CITY OF WOODBURN
COMMUNITY DEVELOPMENT

MEMORANDUM

Date: June 8, 2020
To: Dago Garcia, P.E., City Engineer
Cc: Chris Kerr, AICP, Community Development Director
Roy Hankins, PE, Emerio Design
From: Colin Cortes, AICP, CNU-A, Senior Planner *cc*
Subject: **Planning Division review comments on original / 1st submittal of civil engineering plans for Smith Creek Development Phase 3B**

CURB RETURN - NE CORNER OF KILLIAN AND DESANTIS 11
1" = 5'

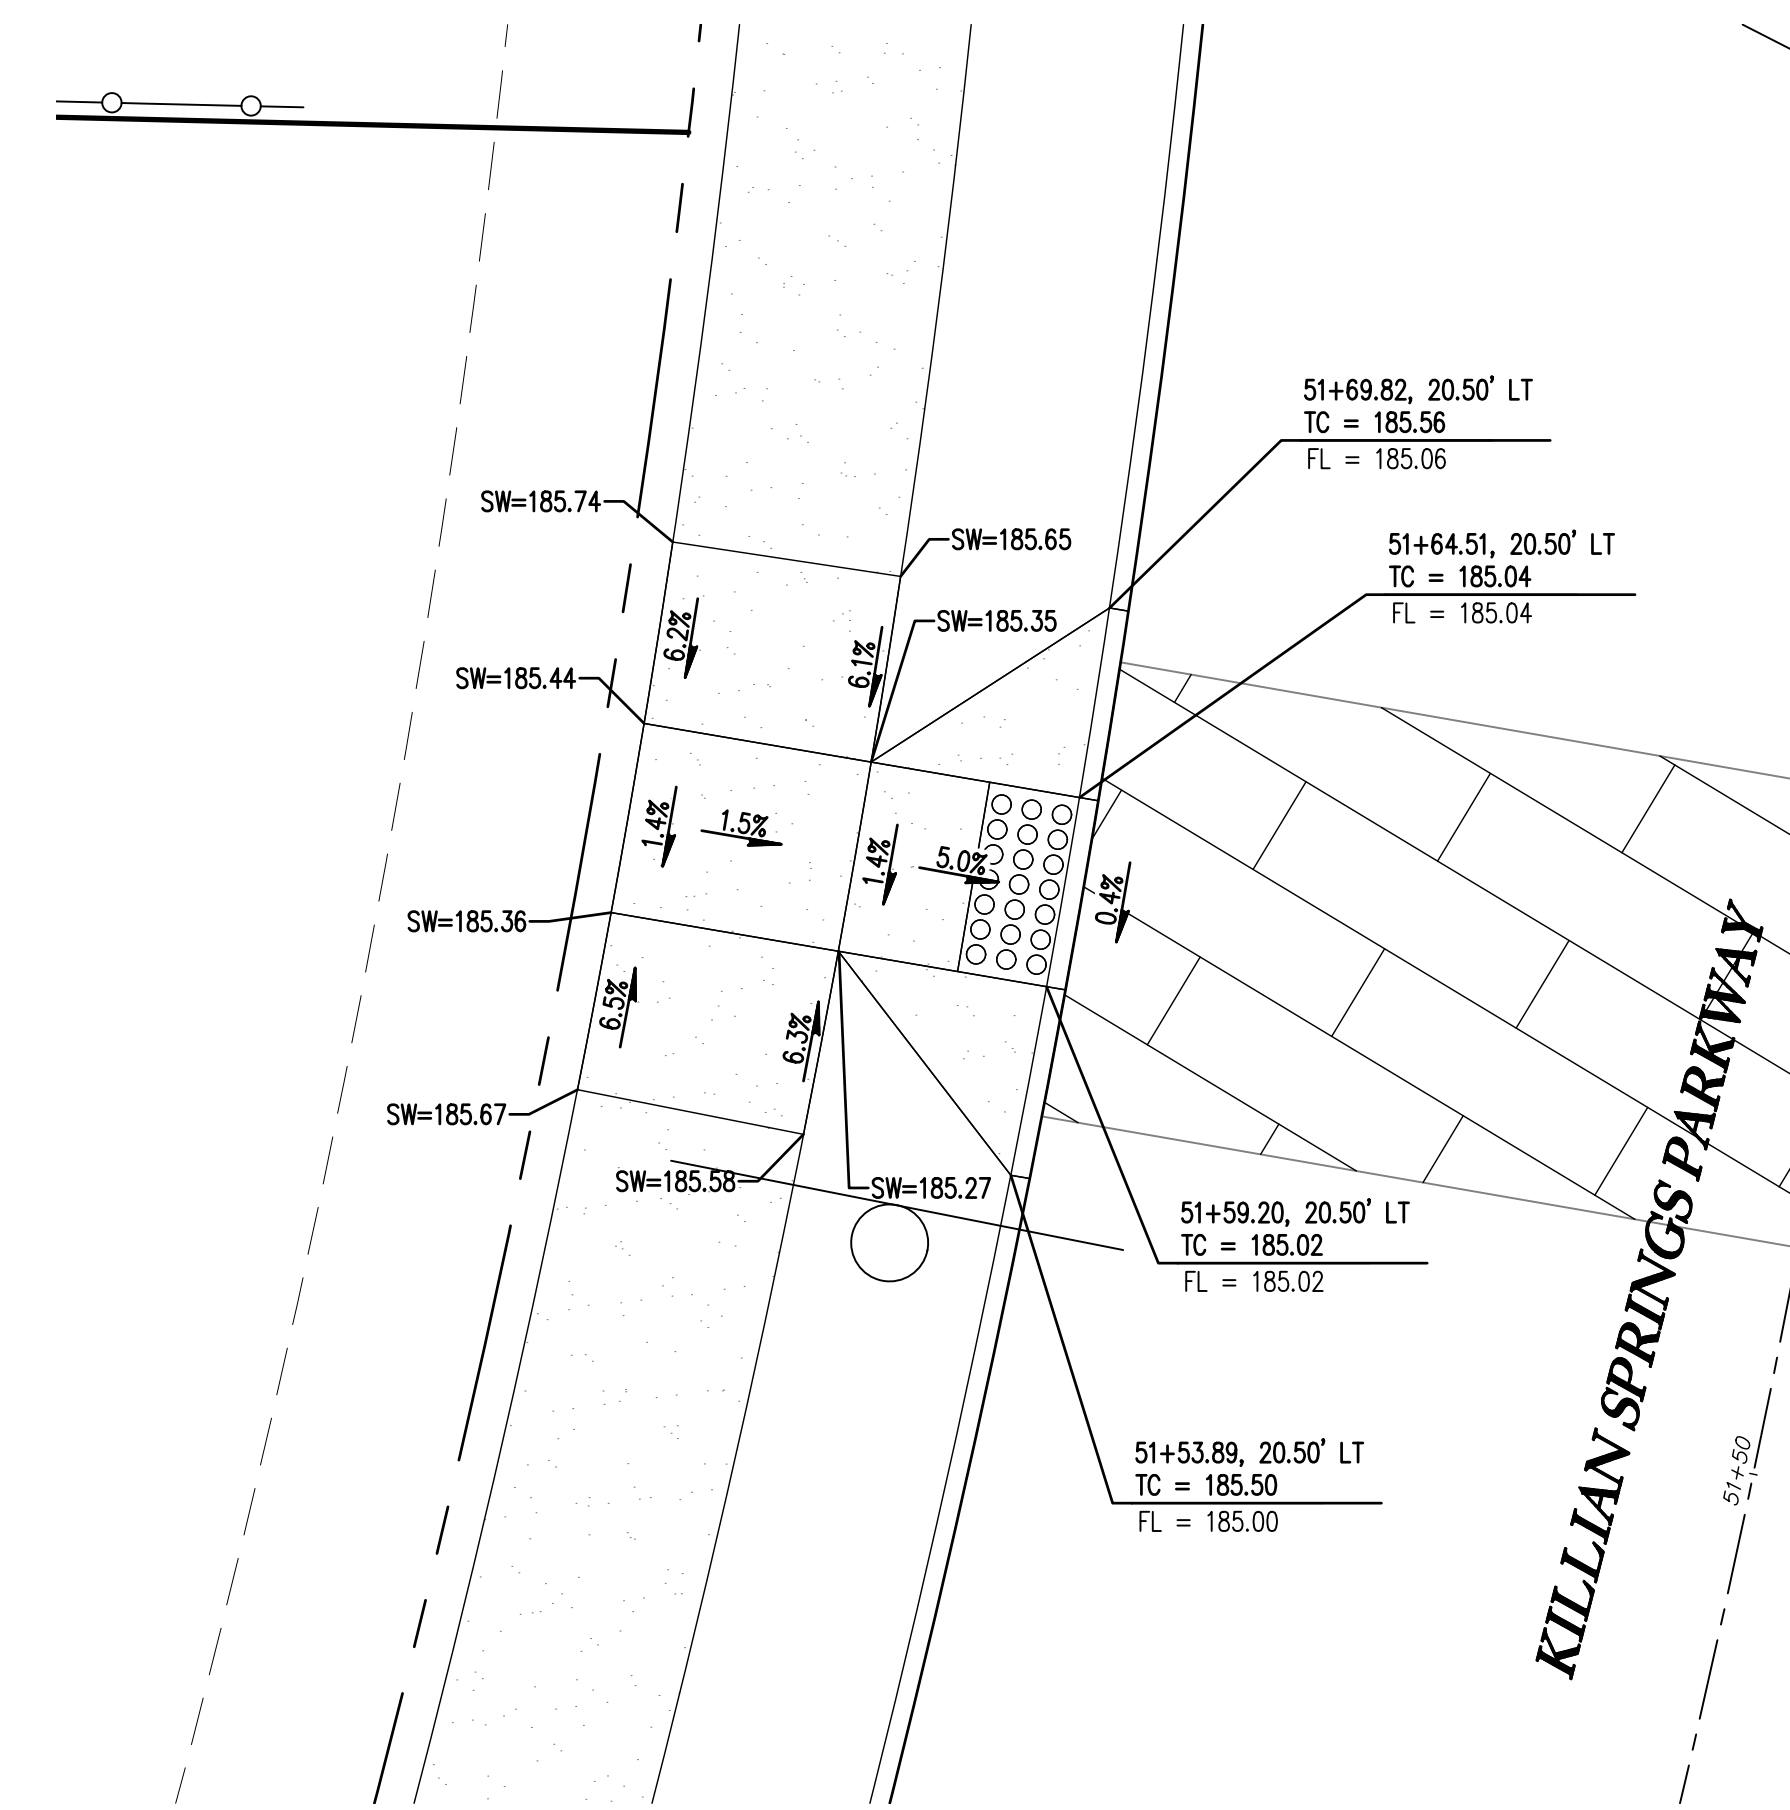
- A. Crosswalk treatments:
 - Sheet 3: Stamped concrete crosswalks typical section; and
 - Sheet 16: Curb return details 7, 9, 10, & 12:

The information is too vague to indicate pavement stamping/treatment, color, and pattern in conformance to the attached excerpted memo I'd sent Stafford Land Co. in August 2019 in response to a request to staff to direct on these topics when the issue first arose for Smith Creek through Phase 1A civil engineering plans.

Revise at least Sheet 3 to indicate conformance with the memo by providing any of notes, diagrams, and images. The excerpted memo is Attachment 1.

KILLIAN SPRING STA 51+50 TO 58+00 & WATER LINE PLAN

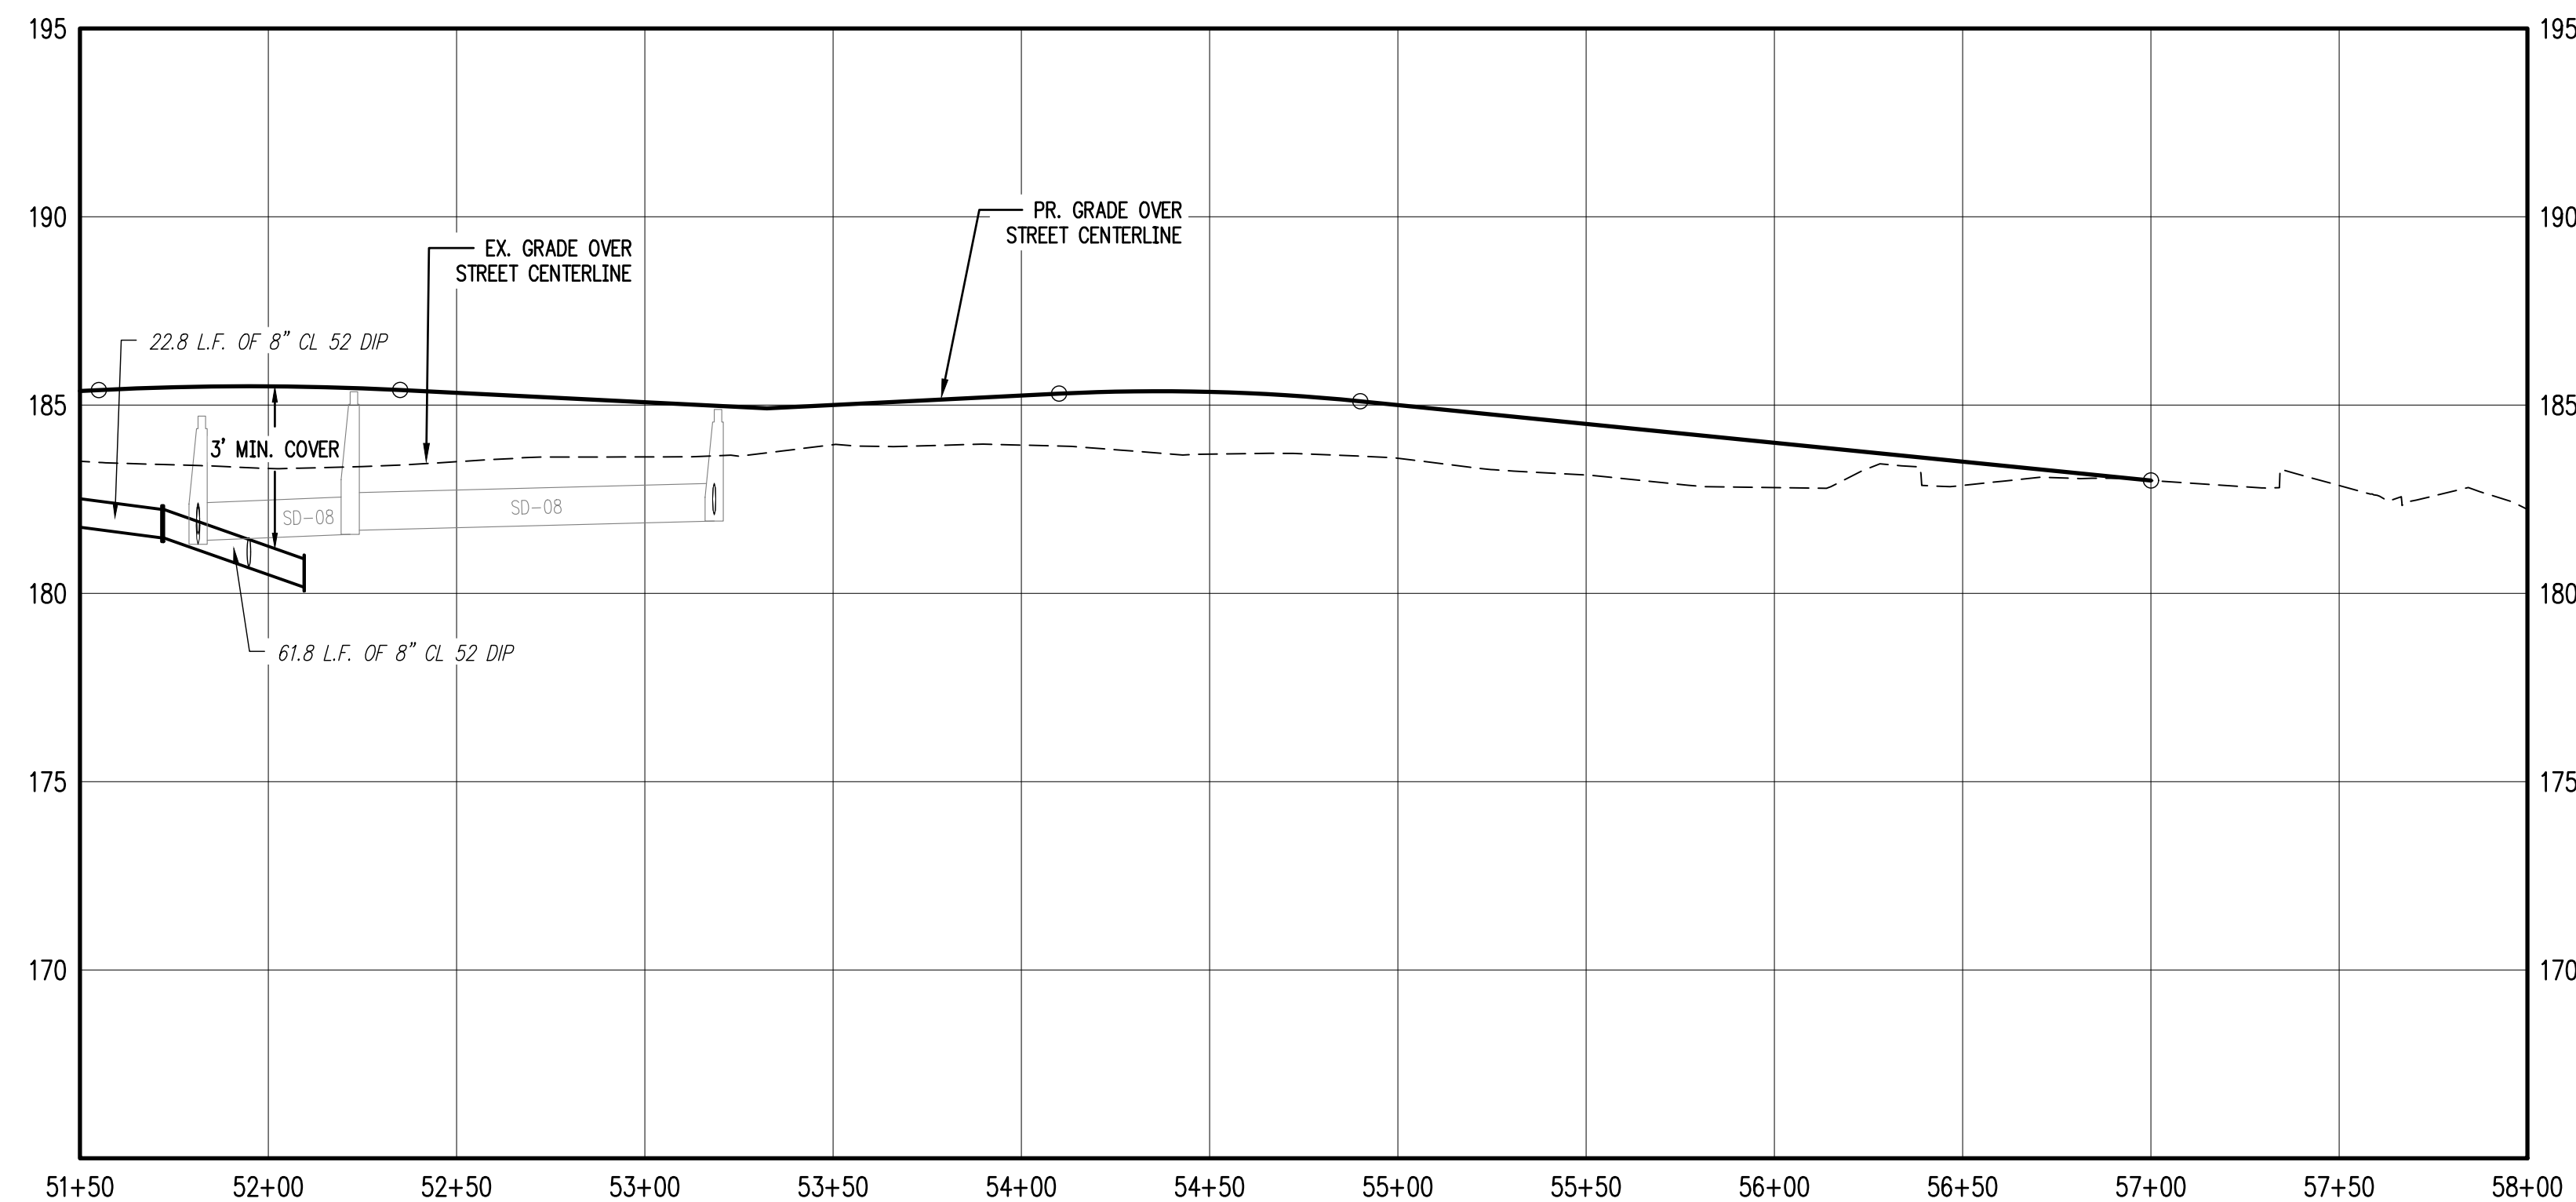
The sheets that show driveway context are missing one of two driveways along Killian Spring Drive on the Nellie Muir E.S. property. They show the north one, but not the south one.

Because it makes perfect sense to build Killian Spring once incorporating driveway approaches / aprons / curb cuts as planned, revise at least Sheet 10 to illustrate and note the south driveway along with the north one and Sheet 20 to illustrate the south driveway along with the north one.
